FC-5C Field Software Change Procedure

Document 51144 Rev A 2/19/99 ECN 99-037

Firmware Change

PROM Replacement

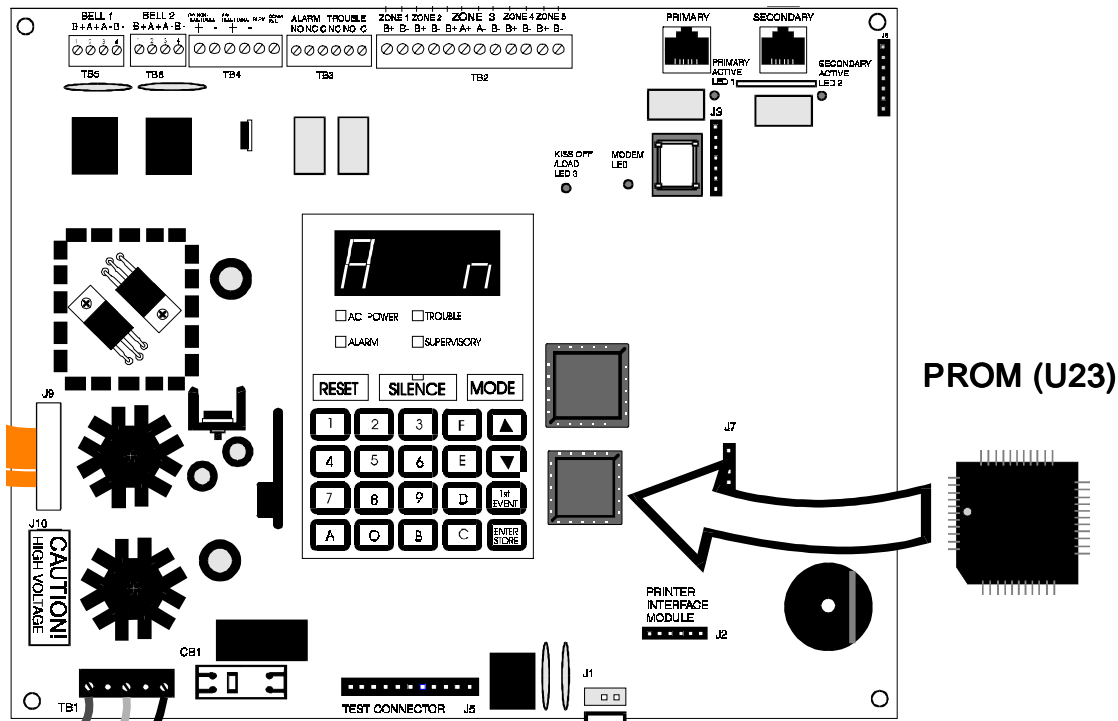
1. Remove all power (AC and battery) before proceeding with PROM replacement.
2. If necessary, disconnect any installed option modules which may inhibit access to PROM.
3. Locate U23 (center right of the board).
4. Gently loosen and remove the PROM from U23.
5. Install the replacement PROM in location U23. Observe proper orientation! The dot on the IC should be positioned to the left and the flattened corner of the IC should align with the flattened corner of the socket. Use care to insure that the PROM's pins are not bent or broken during insertion.
6. Reconnect any option modules which were removed in Step 2.
7. Reconnect power (AC and batteries).
